**MANDATORY BULLETIN No. SportStar-043a SR
SAFETY RELATED**

- 1. CONCERNING:** All SportStar airplanes.
- 2. REASON:** Unification of the strength class of the fastening bolts in the joint of the engine and the engine mount hinges and the resulting minimization of the possibility that these bolts will be accidentally interchanged.
- 3. REQUIRED ACTIONS:**
 1. Replace the fastening bolts in accordance with the bulletin text.
 2. Record the replacement in the Aircraft Logbook.
- 4. LATEST DAY OF THE ACTION:** Within 30 calendar days of the issue of this bulletin or during the next scheduled service inspection, whichever occurs first.
- 5. CARRIED OUT BY:** Organizations authorized for maintenance / repairs of this type of airplane.
- 6. COSTS COVERED BY:** Airplane owner/operator.
- 7. NECESSARY MATERIAL:** In accordance with the bulletin text.
- 8. WORK PROCEDURE:** In accordance with the bulletin text.
- 9. APPENDICES:** None.

Valid from: June 19th, 2023

Fig. 1 – Securing the engine against falling

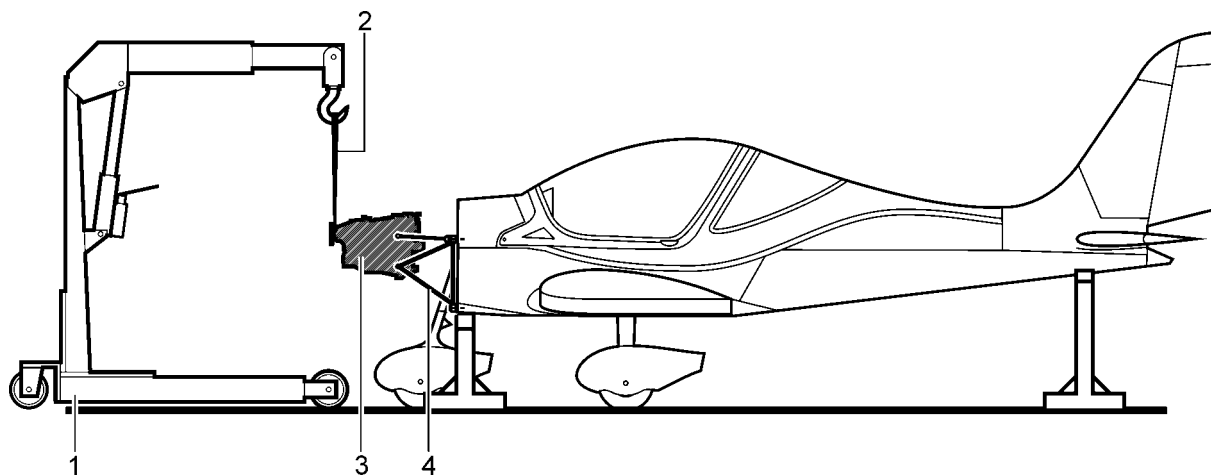
- 1.3.1.8 Secure the ends of the removed hoses with suitable plugs against the ingress of dirt.
- 1.3.1.9 Hang the engine (3, Fig. 1) on the workshop crane (1) using the suspension strap (2). The engine (3) is now secured against falling.
- 1.3.1.10 Remove the cotter pins and plugs (5, 7, Fig. 3) from the bolts (1, 2, 3, 4, Fig. 2) in the joint of the engine and the engine mount hinges.

- 1.3.1.21 Release the engine from the mounting crane (Fig. 1).
- 1.3.1.22 Remove all plugs from hoses or devices.
- 1.3.1.23 Attach all hoses which were previously removed to gain access to the bolts.

Fig. 2 – Engine mount – position of fastening bolts

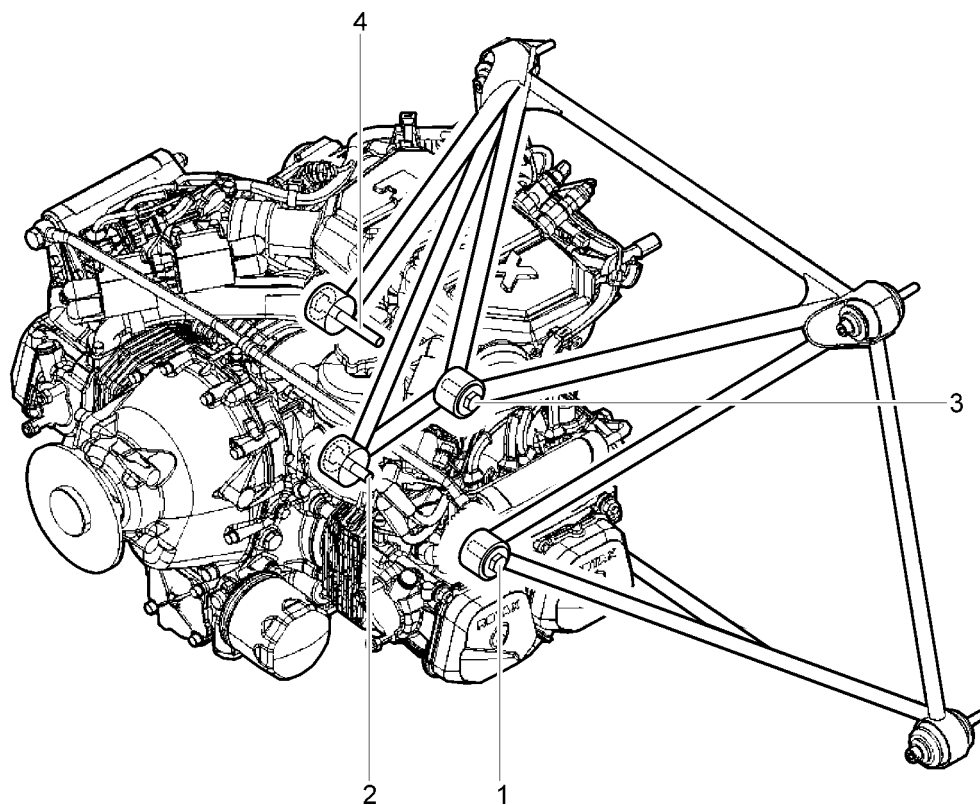
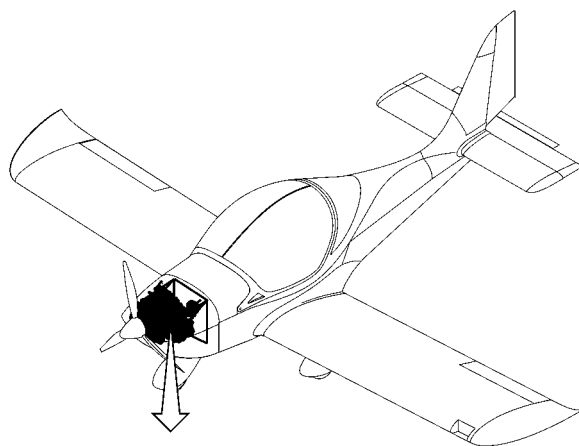
- 1.3.1.11 Remove the bolt (1) from the joint of the engine and the engine mount hinges. Immediately replace the removed bolt with a new one and tighten it slightly.

- 1.3.1.12 Remove the bolt (2) from the joint of the engine and the engine mount hinges. Immediately replace the removed bolt with a new one and tighten it slightly.

- 1.3.1.13 Remove the bolt (3) from the joint of the engine and the engine mount hinges. Immediately replace the removed bolt with a new one and tighten it slightly.

- 1.3.1.14 Tighten the bolt (4) in the joint of the engine and the engine mount hinges using a torque wrench with a torque of 40 Nm. This bolt is the only one that is not replaced, but the tightening torque value is changed from 35 Nm to 40 Nm.

- 1.3.1.15 Tighten the bolts (1,2,3) in the joint of the engine and the engine mount hinges using a torque wrench with a torque of 40Nm.
- 1.3.1.16 Put the plugs (5, Fig.3) on the bolts (4), (1,2,3,4, Fig.2).

*Fig. 3 – Engine suspension*

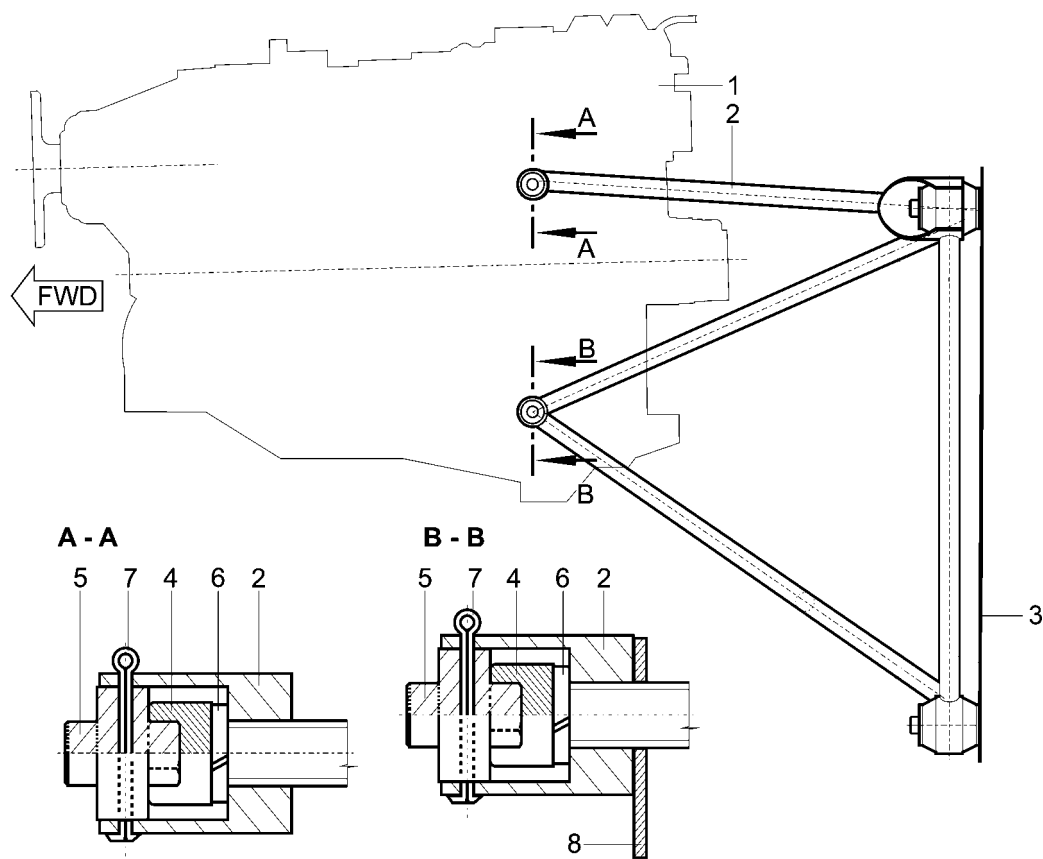
- 1.3.1.17 Mark the plugs (5, Fig. 3) with a marking pin in accordance with the holes in the engine mount hinges (2) on both sides.
- 1.3.1.18 Remove the plugs (5) from the bolts (4) and drill through them with a $\varnothing 2,1$ mm drill bit in accordance with the marks made by the marking pin.

- 1.3.1.19 Put the plugs (5) back on the bolts (4) so that they align with the holes in the engine mount hinges (2).
- 1.3.1.20 Use the cotter pins (7) to secure the bolts (4) with the plugs (5) in the joint of the engine and the engine mount hinges (2).
